DriveLogix™ Controller Firmware Revision 11 / RSLogix 5000 Version 11

These release notes correspond to major revision 11, minor revision 14 of the DriveLogix controller firmware. Use this firmware release with:

Publication 20D-RN003A-EN-P - October 2002

Use the Same Tag in Multiple IREFs and OREFs

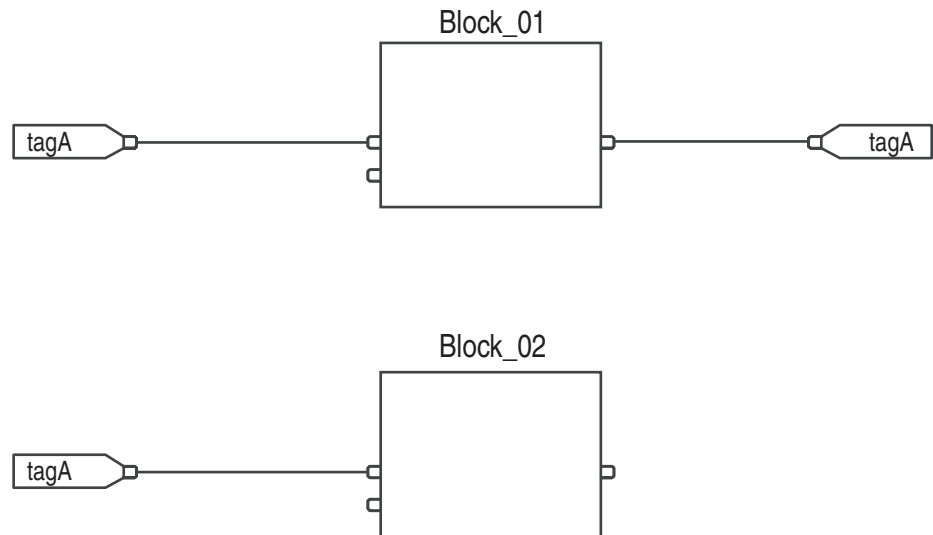
You can use the same tag in multiple IREFs and an OREF in the same routine. Because the values of tags in IREFs are latched every scan through the routine, all IREFs will use the same value, even if an OREF obtains a different tag value during execution of the routine. In this example, if tagA has a value of 25.4 when the routine starts executing this scan, and Block_01 changes the value of tagA to 50.9, the second IREF wired into Block_02 will still use a value of 25.4 when Block_02 executes this scan. The new tagA value of 50.9 will not be used by any IREFs in this routine until the start of the next scan.
